## Proposed Plan Change 58:

### Information requested by the Panel

#### Supplementary to the Evidence of Naomi McMinn (Transport) (26/2/2024)

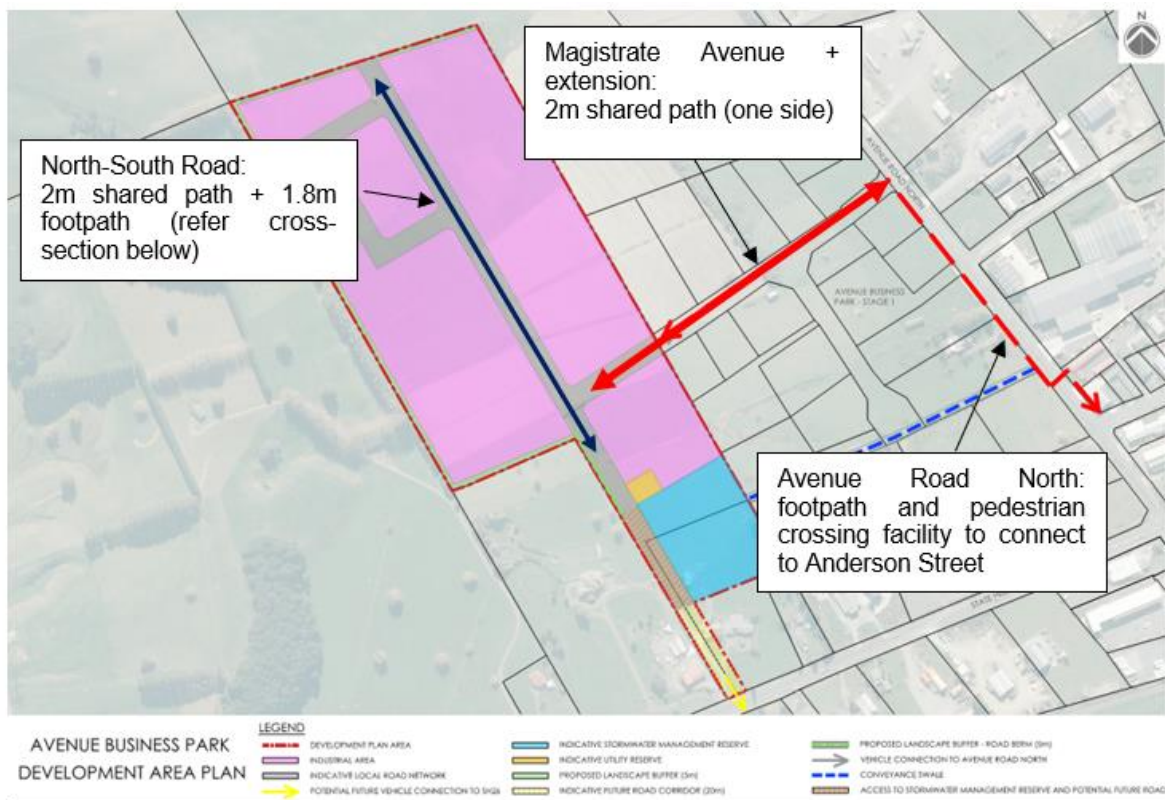
2. You asked for path widths to be shown on the ADAP.

**Response:** These are indicated on the ADAP below and the recommended cross-section for the north-south road including shared path on one side and footpath on the other.
